From: Damien Lockyer <damien.lockyer@mainroads.wa.gov.au>
Sent: Monday, 22 December 2025 12:25 PM
To: Enquiries
Cc: Regan Travers; Tracey Cooney Walshe; Cardia Mariani
Subject: [Email Response to Council] PG-DEV-067 - Wattle Grove South Local Structure Plan – City of Kalamunda
Attachments: [Response to Council] PG-DEV-067 - Wattle Grove South Local Structure Plan – City of Kalamunda.pdf

INFORMATION REQUEST – PROPOSED WATTLE GROVE SOUTH LOCAL STRUCTURE PLAN – VARIOUS LOTS IN WATTLE GROVE – REF PG-DEV-067

Attachment A - Plan 1 – Local Structure Plan (Marked Up)

Plan 1 – Local Structure Plan

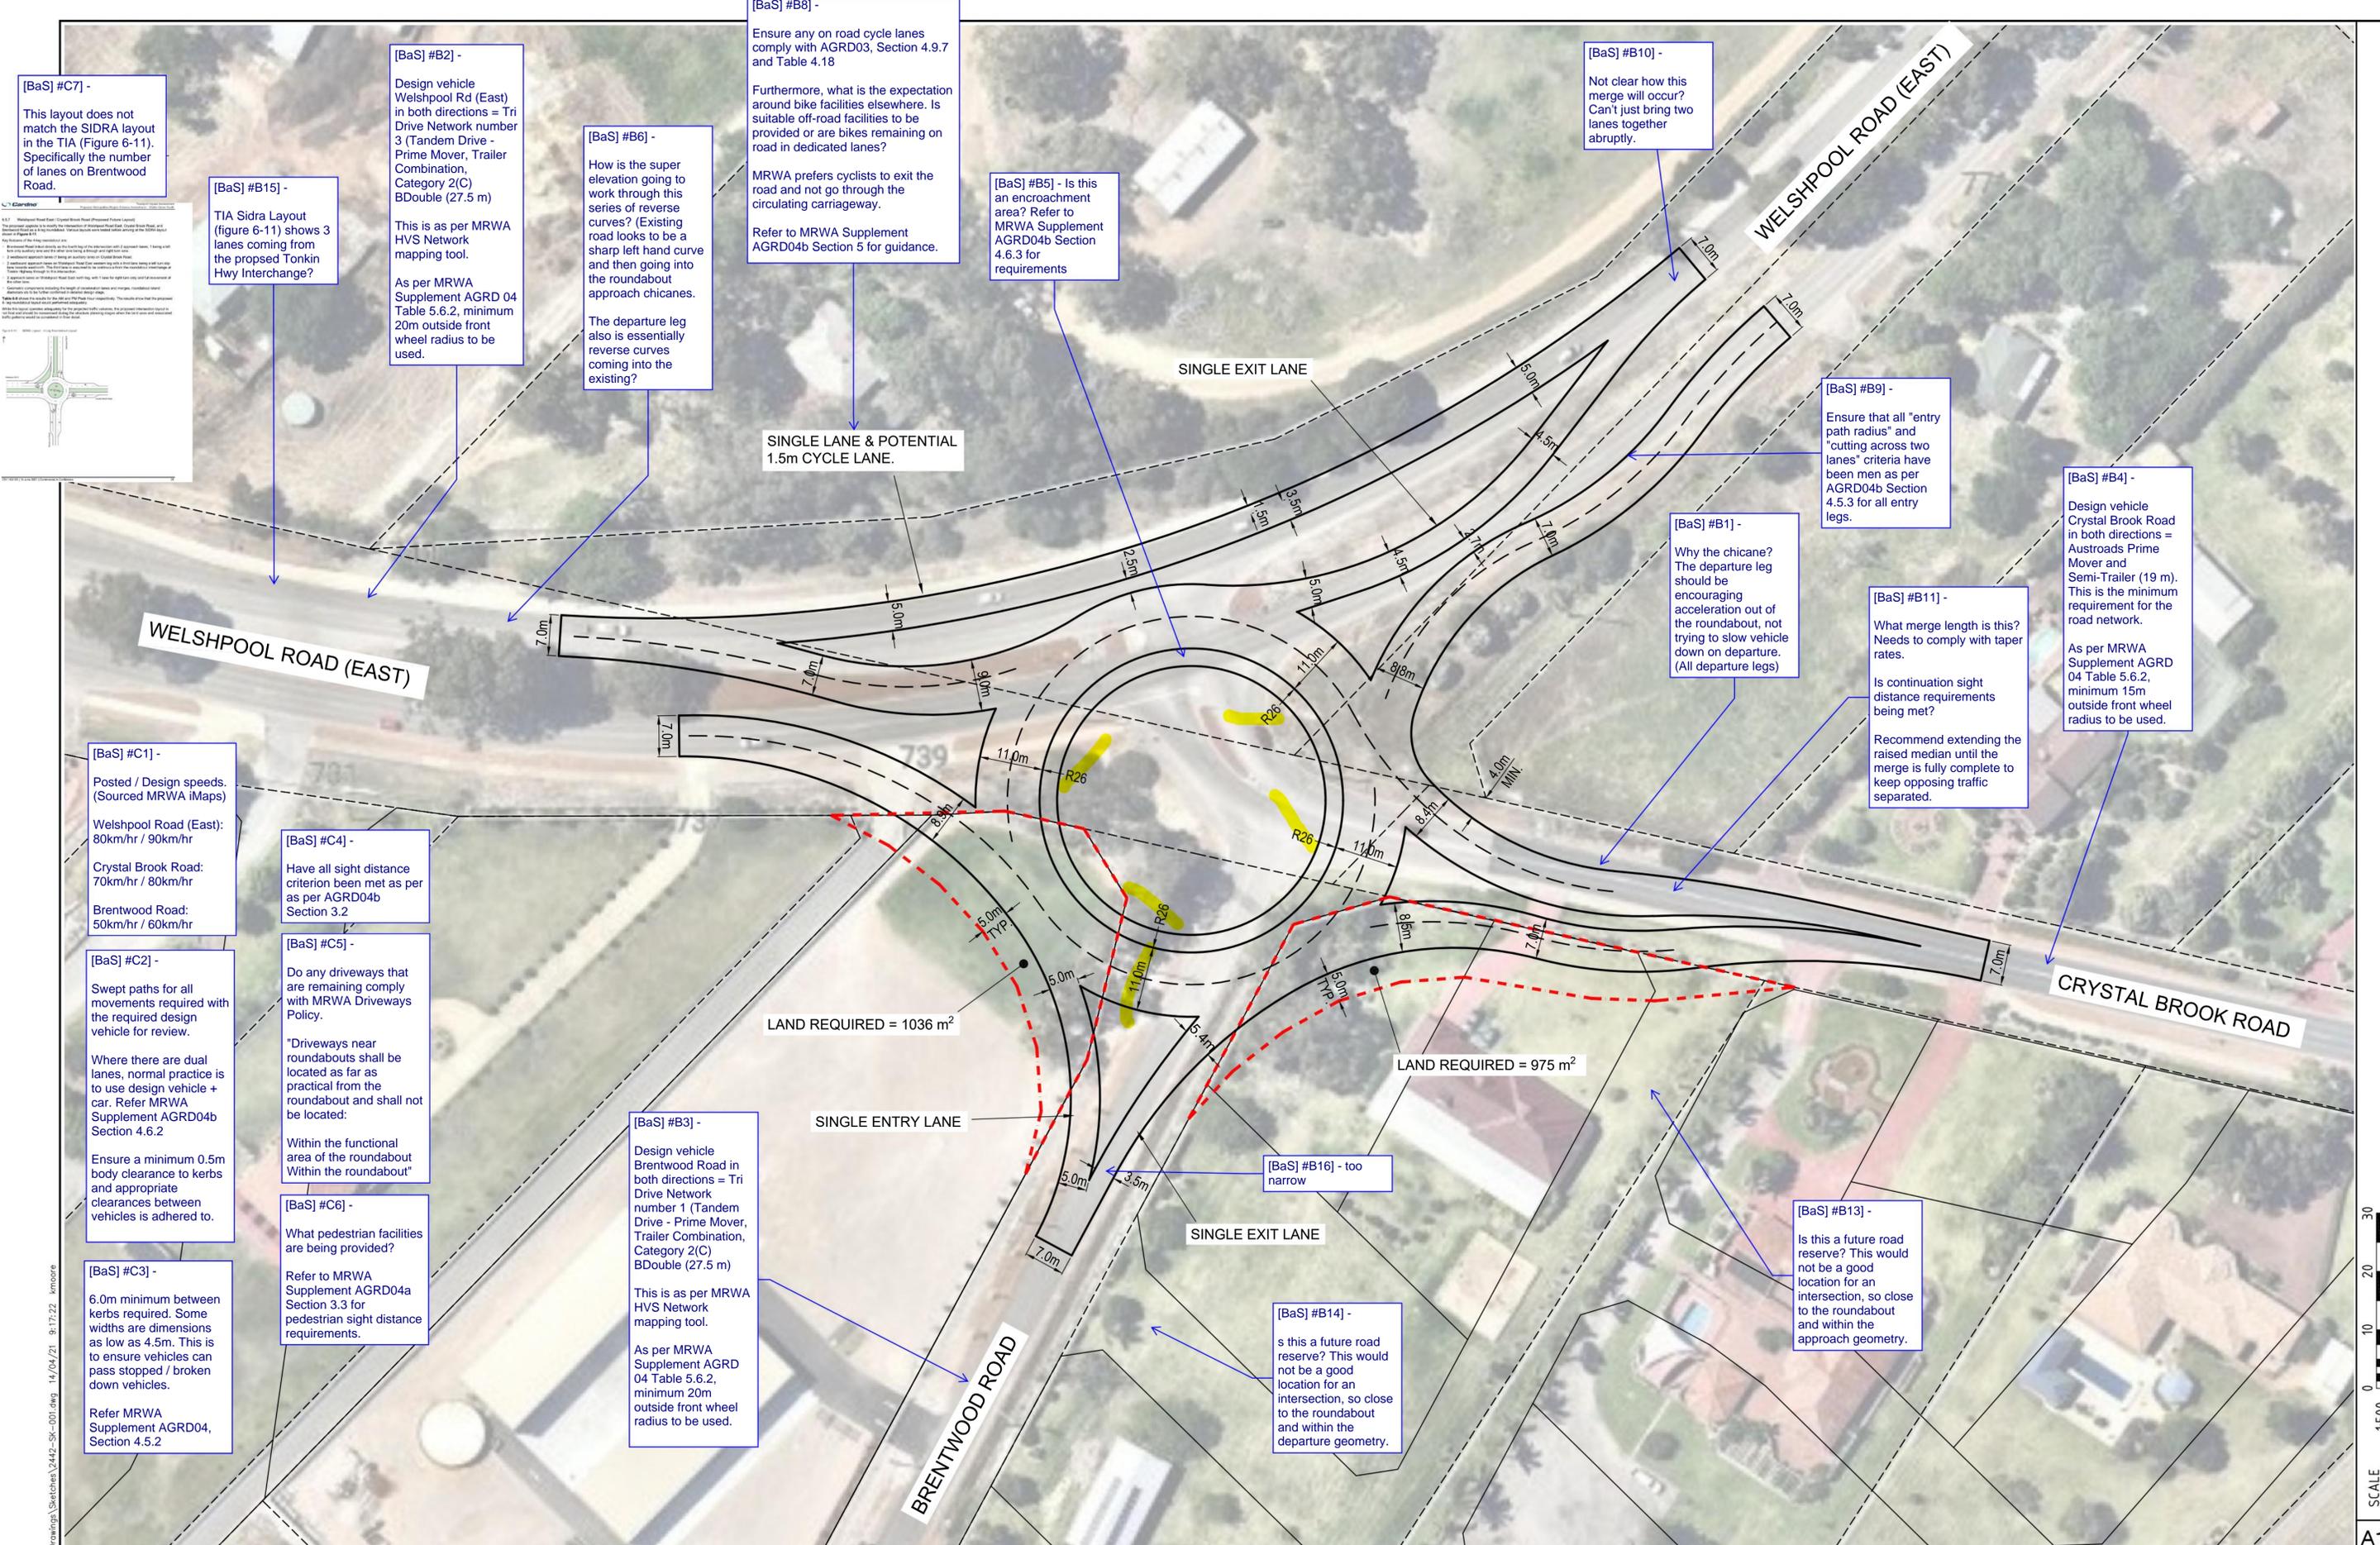
Vehicle Access	
3.0	<p>Two (2) full-movement access points are proposed onto Crystal Brook Road approximately 70 metres apart. One (1) full-movement access must be removed as per Attachment A (enclosed). The two (2) proposed access points are within close proximity and will impact road safety and road network performance.</p> <p>Action Required – Applicant to update TIA and structure plan.</p>

3.1	<p>Future LILO Access Point - not supported</p> <p>The proposed future left-in/left-out (LILO) access point onto Welshpool Road East from Lot 2 (No.731) Welshpool Road East within Precinct A must be removed.</p> <p>This access point impacts the functional area of:</p> <ul style="list-style-type: none"> • The existing traffic signals at the Tonkin Highway / Welshpool Road East intersection. • The future 4-way roundabout at Welshpool Road East / Brentwood Road / Crystal Brook Road. <p>The future 4-way roundabout can accommodate this traffic demand, therefore the LILO access point should be removed from the Structure Plan and all supporting technical documents.</p> <p>Action Required – Applicant to update TIA and structure plan.</p>
